**Section 205 Flood Risk Reduction Continuing Authorities Program (CAP)
Conversion Project
Rio Culebrinas in Aguada and Aguadilla, Puerto Rico**

**U.S. Army Corps of Engineers, Jacksonville District (Corps) Responses to
Puerto Rico Planning Board (PRPB) Coastal Zone Management Program
Request for Additional Information**

ROAD RAMPS / UTILITIES RELOCATIONS

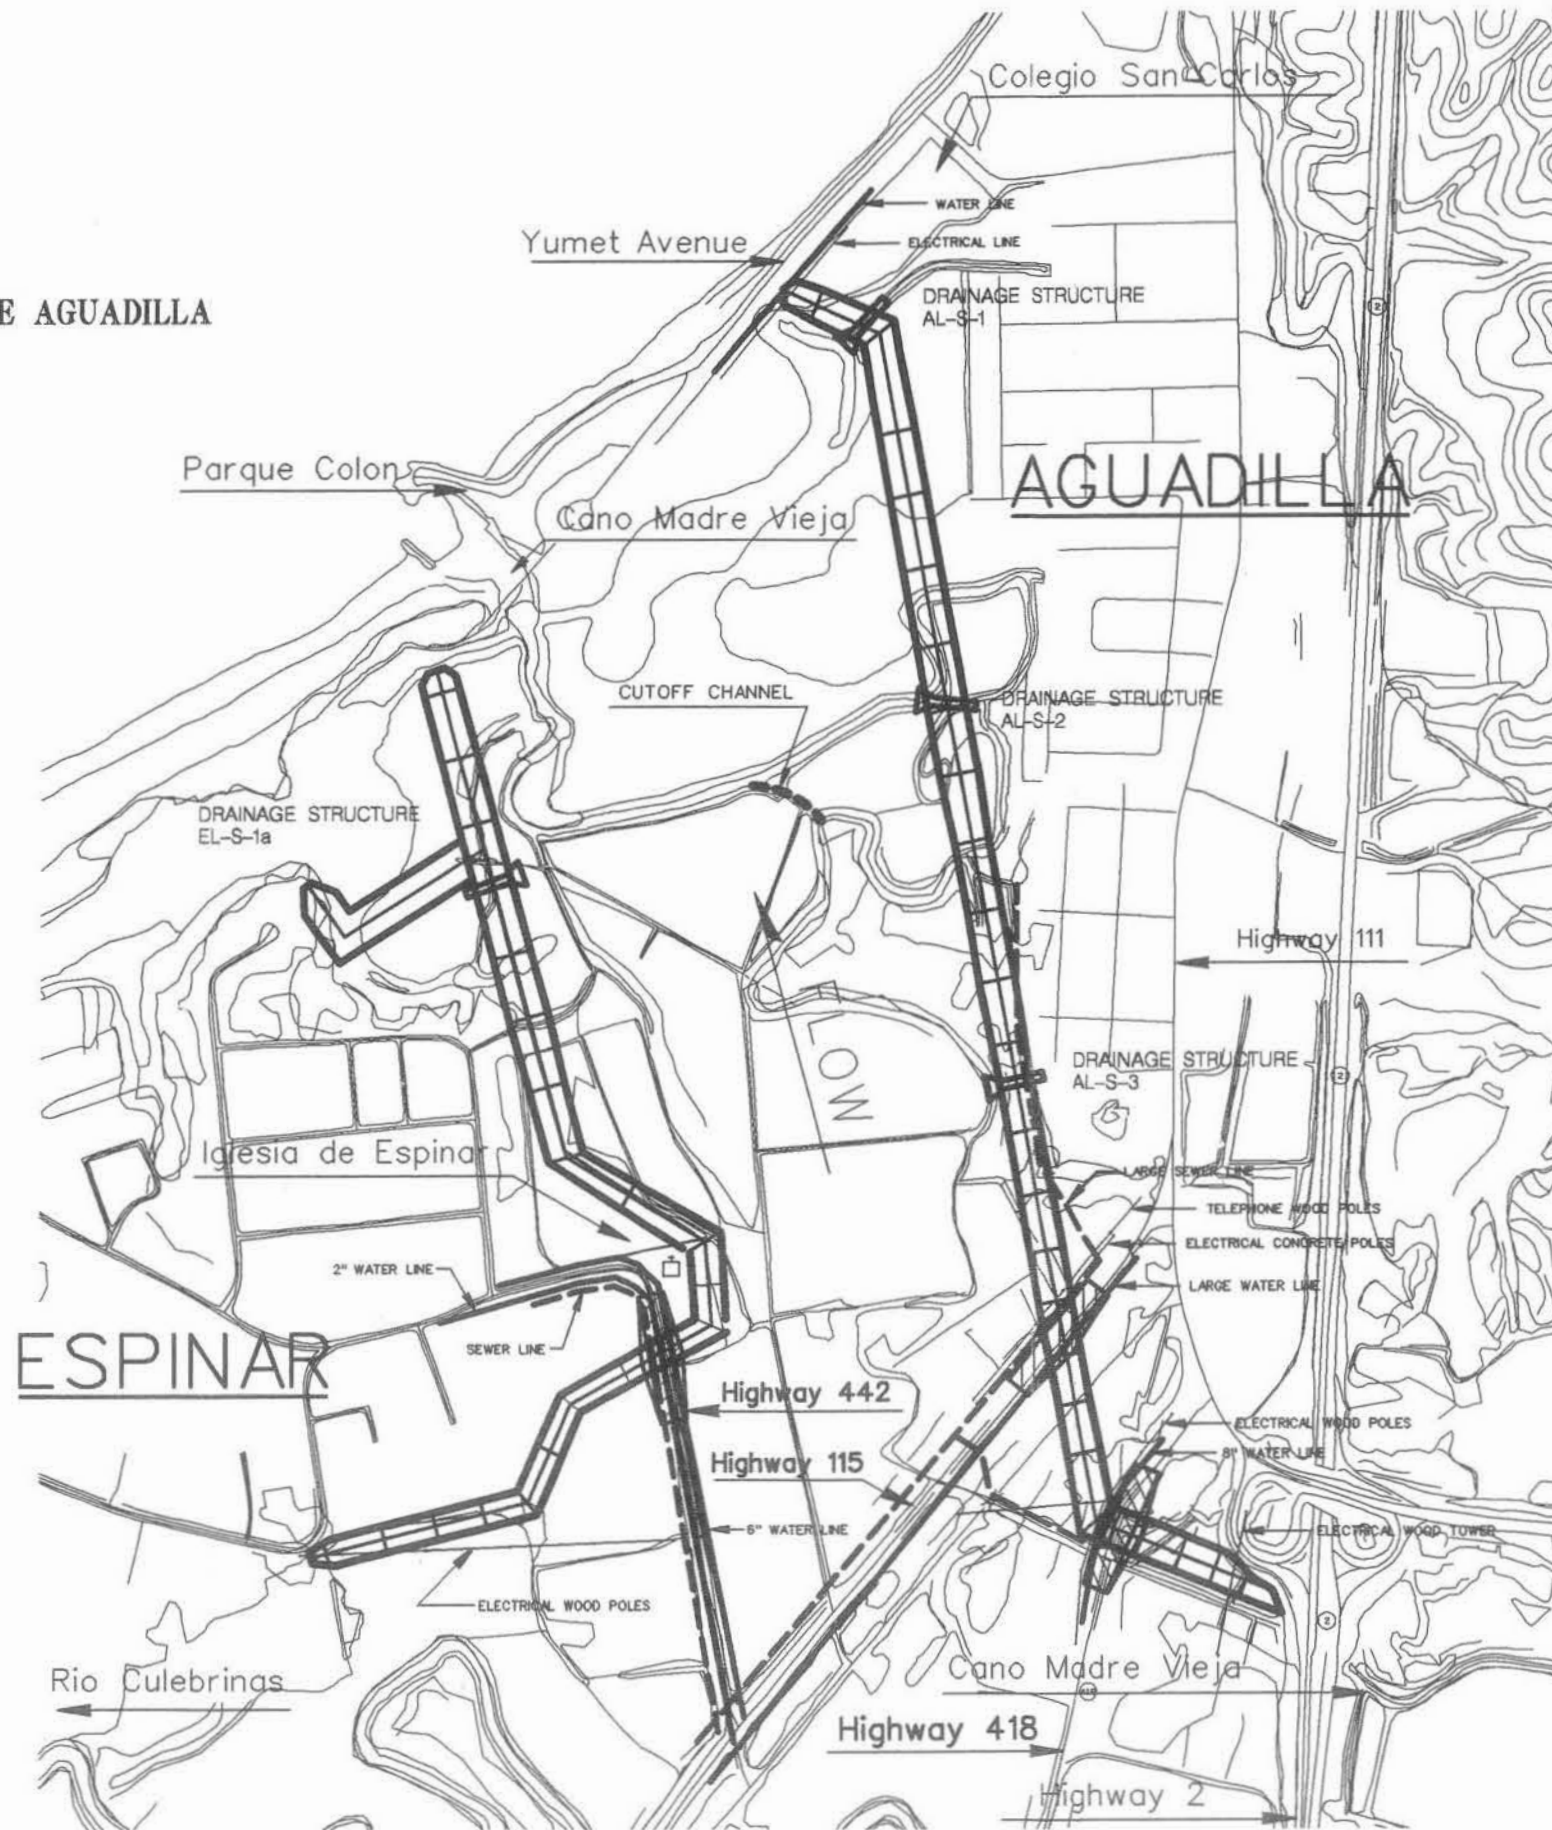
4. *The location of the proposed drainage channels are not shown in the provided maps and drawings. The drawings for the proposed project must include all the features to be constructed as part of the project.*

The Corps has provided additional drawings with this letter enclosure. Please see Attachment 1. Detailed design engineering drawings will be developed in the project's PED phase. Typical drawings showing individual features to be included in the design are included in Attachment 1.
